Expert Opinion

Pakenham East Precinct Structure Plan

Panel Hearing: Amendment C234 to the Cardinia Shire Planning Scheme

May 2018

Figure 6-4 – Possible Deep Creek Corridor Works (source: Stormy Water Solutions, 2014)

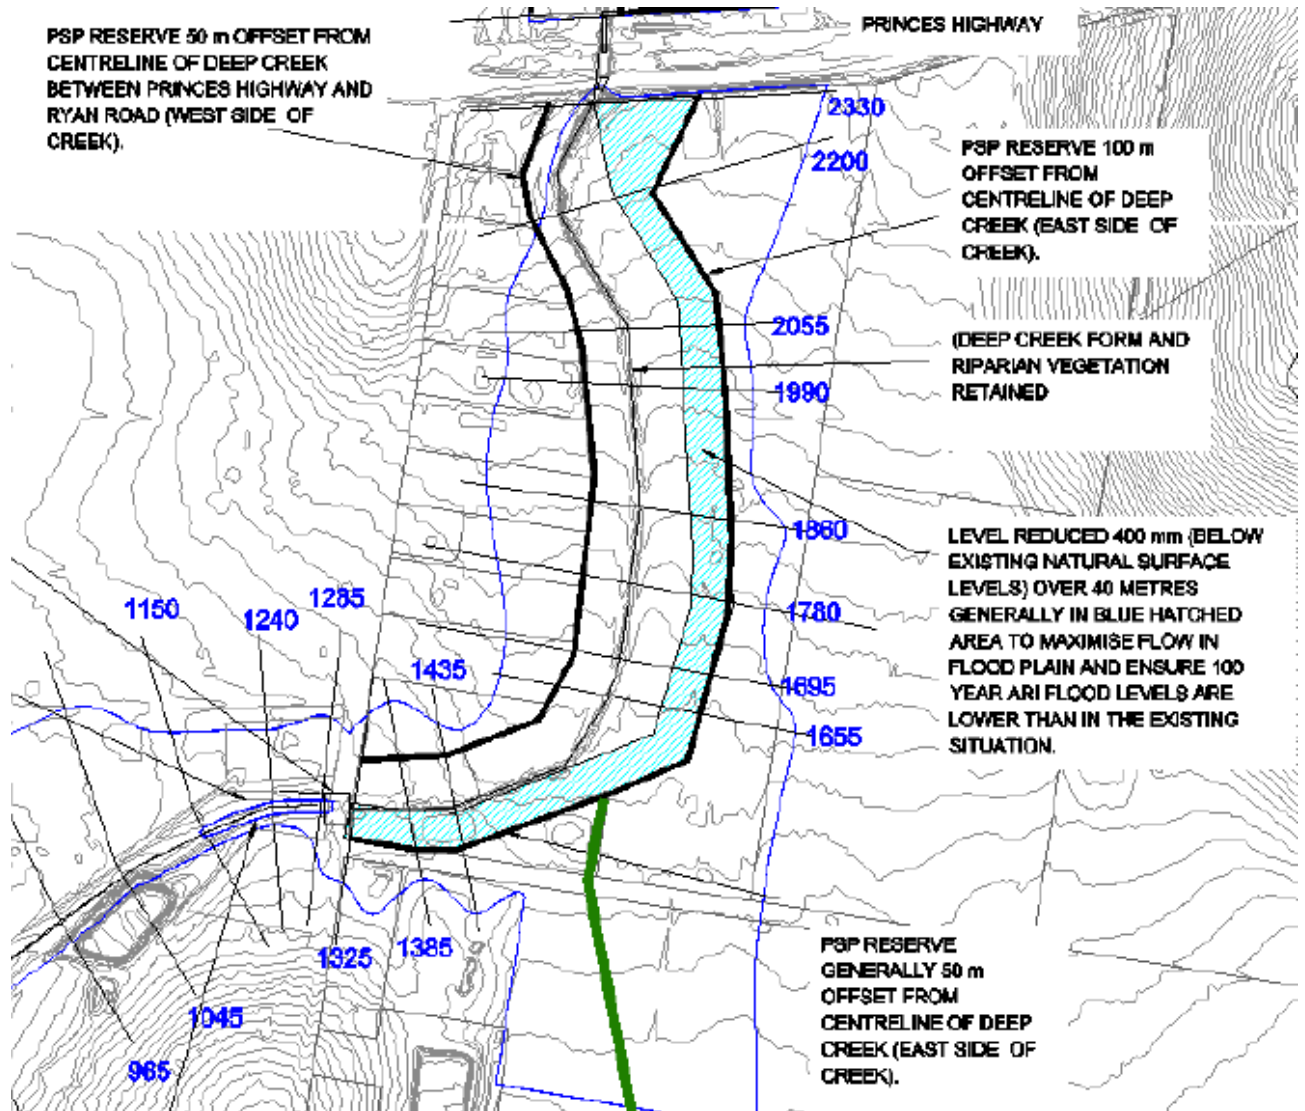
The proposed drainage strategy (Stormy Water Solutions, Dec 2017) for the Pakenham East PSP provides initially for a 100 m corridor along Deep Creek (east bank) within the site reducing to a 50 m corridor near Canty Lane. We understand, that the proposed waterway corridor setback has been determined by flood flows and flood levels within the 1% AEP floodplain. It is noted that the original strategy concept contained a 50 m corridor on the eastern side.

Physical modifications within the proposed waterway corridor are proposed to facilitate floodplain conveyance. These are outside the existing vegetated riparian corridor but within the broader waterway corridor, with cut proposed to reduce levels by 400 mm below existing natural surface levels, as shown in Figure 6-4.

Figure 8-1 – Existing Flood Depths within the Subject Site

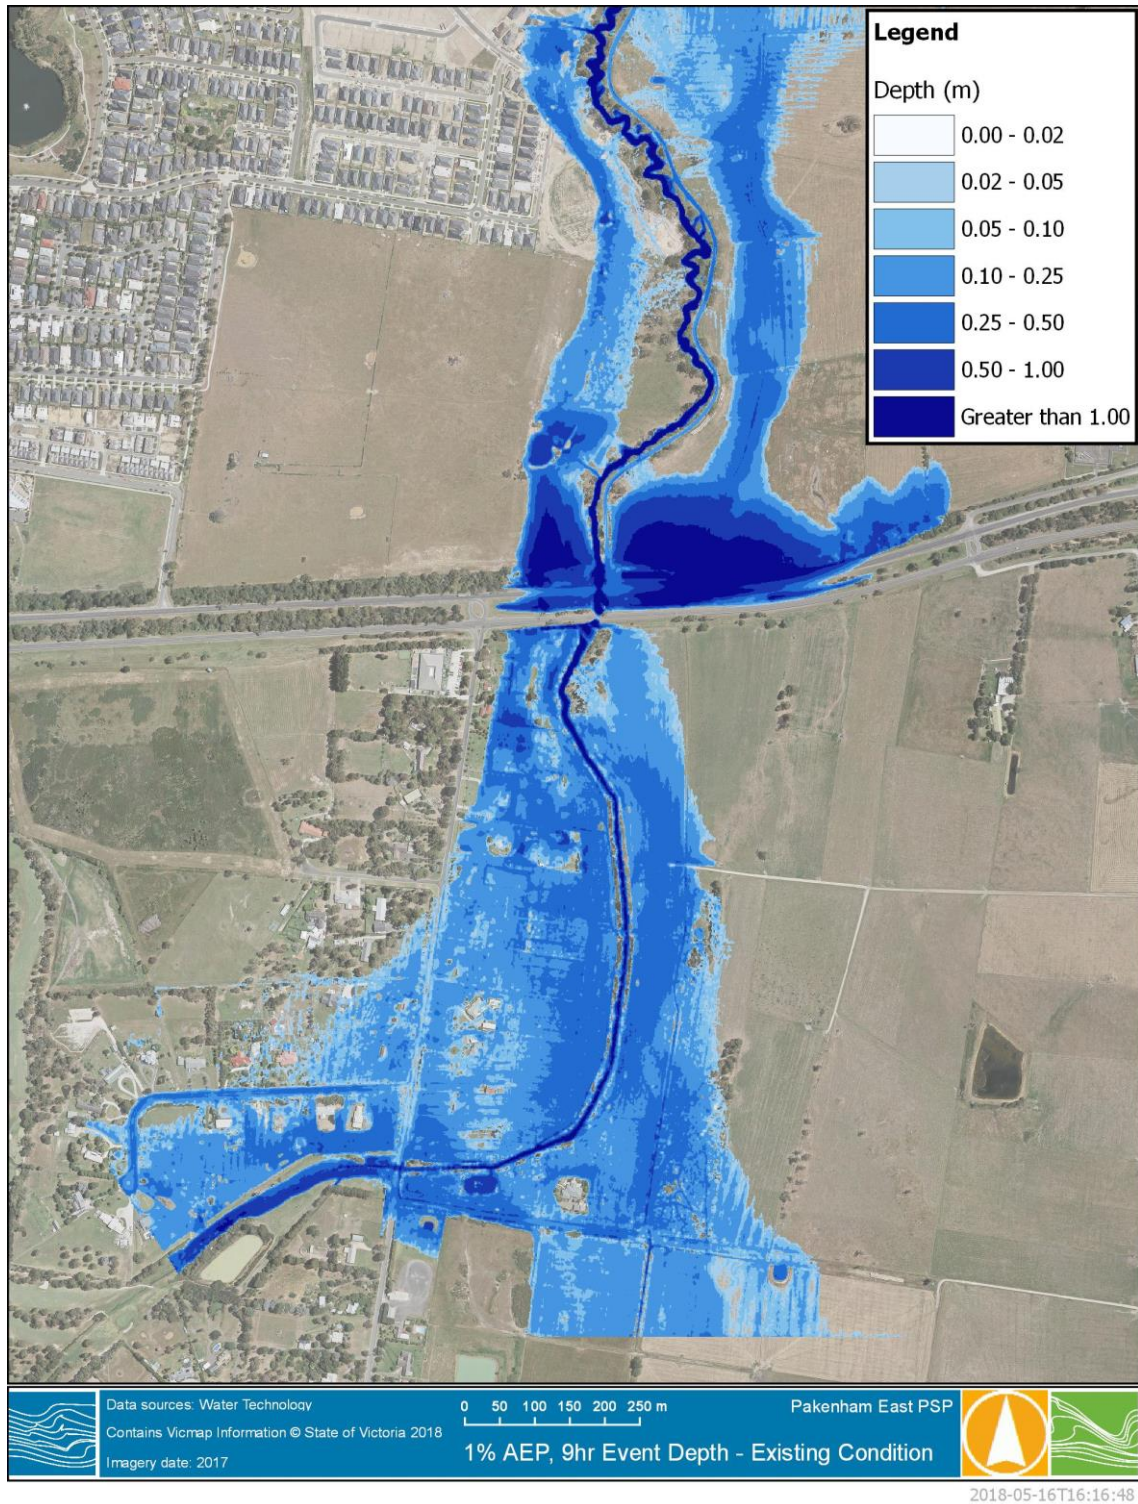
Our hydraulic model results confirm that Deep Creek breaks its banks during the critical 1% AEP design flood event (9hr) through the site, with major floodways east and west of the main channel, as shown in Figure 8-1 and Figure 8-2. The flood extent and flood levels from the TUFLOW model are generally similar to those from Stormy Water Solutions' Hec Ras model. However, it is noted that the flood extent is wider to the west, through the existing rural residential area. Additionally, the Hec Ras model (and declared flood plain extent) may under-estimate the importance of the break-away flow to the south. Figure 8-3 shows the split of flows in the deep Creek floodplain at the downstream boundary of the site predicted by the 2D model. This suggests that, during extreme floods, a significant portion of Deep Creek flow (around 50%) may break away from Deep Creek and flow south under existing conditions.

The modelling highlights that on both the western and eastern floodplain, inundation generally extends more than 100 m from the Deep Creek channel, although depths are mostly quite shallow. Works within the floodplain and/or riparian zones are therefore required to accommodate the flood flows within a reduced waterway corridor for the works currently proposed under the PSP.

Figure 9-1 – 1% AEP - Post-Development Flood Depths

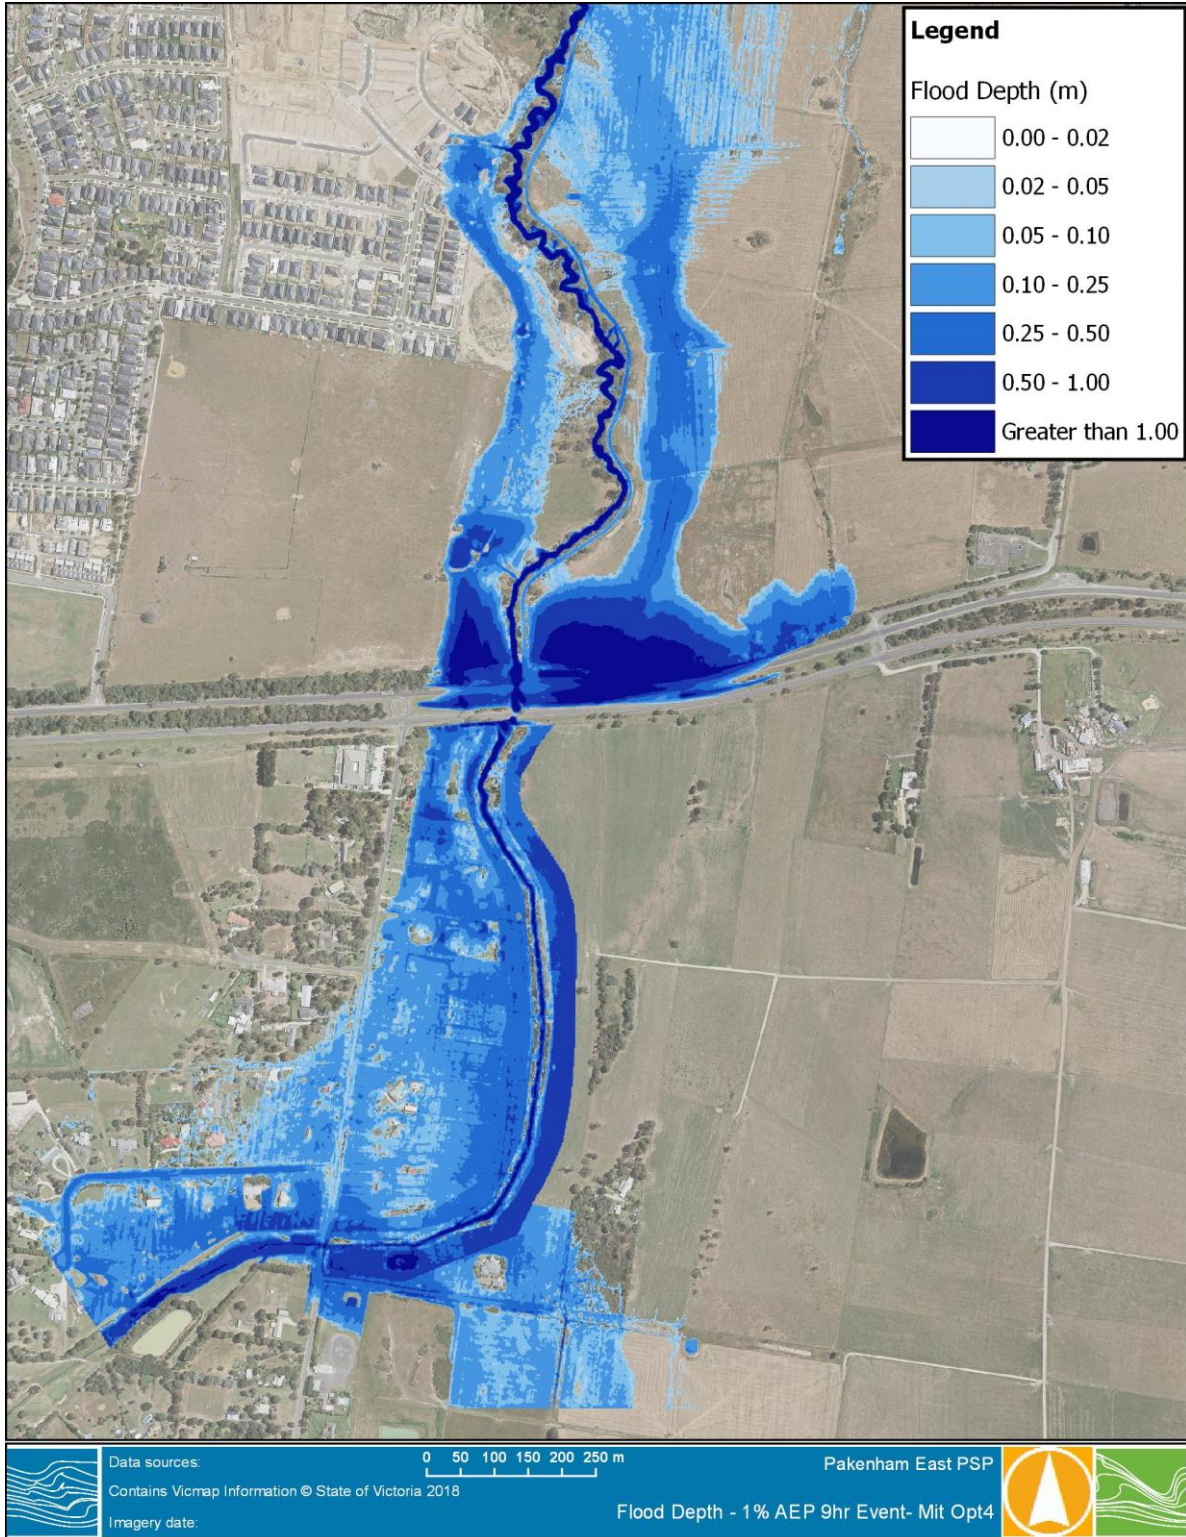
I have modelled a preliminary version of Option 2 to demonstrate the potential for this to function hydraulically. It should be noted that the scenario was modelled as a proof-of-concept and further refinement of the modelling/design would be required to demonstrate the effectiveness of this approach. Figure 9-1 shows the depths for the Option 2 configuration in a 1% AEP design flood event. Figure 9-2 shows the model predicted water level difference which is calculated by subtracting the existing peak water surface from the developed peak water surface. This shows positive values where the developed conditions levels are higher and negative values where the developed conditions levels are lower.

Figure 9-2 – 1% AEP - Water Surface Elevation Difference Plot (Developed minus Existing Conditions)

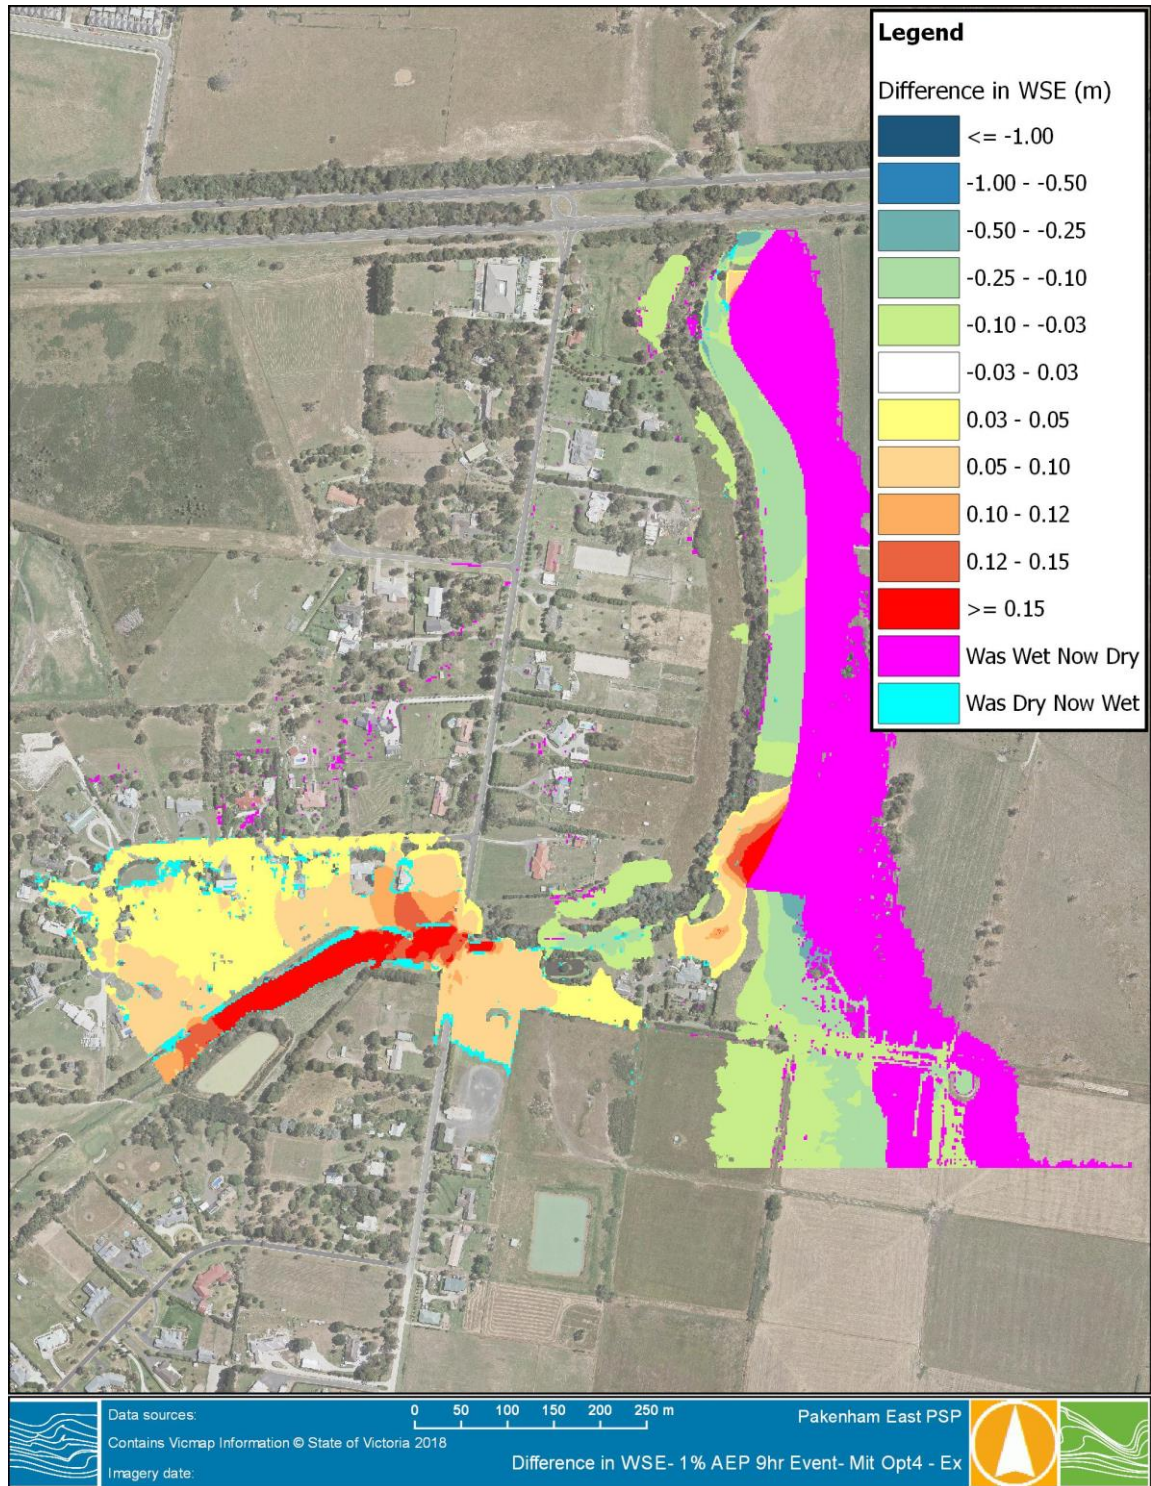
The magenta area in Figure 9-2 shows areas that were previously flooded and are now dry. The areas that are yellow to red show that levels have increased. This is particularly evident at the downstream end of the site and downstream of Ryan Road. There is a corresponding reduction in levels to the east. The main cause of the increases downstream is that the reduced levels in Deep Creek through the subject site have resulted in a significant decrease in breakout flow to the south. The flow down the Deep Creek channel is predicted to be 26 m³/s compared to 16 m³/s under existing conditions. The extra flow in Deep Creek downstream of Ryan Road causes levels to be elevated. This impact could be mitigated through optimisation and refinement of the channel geometry.
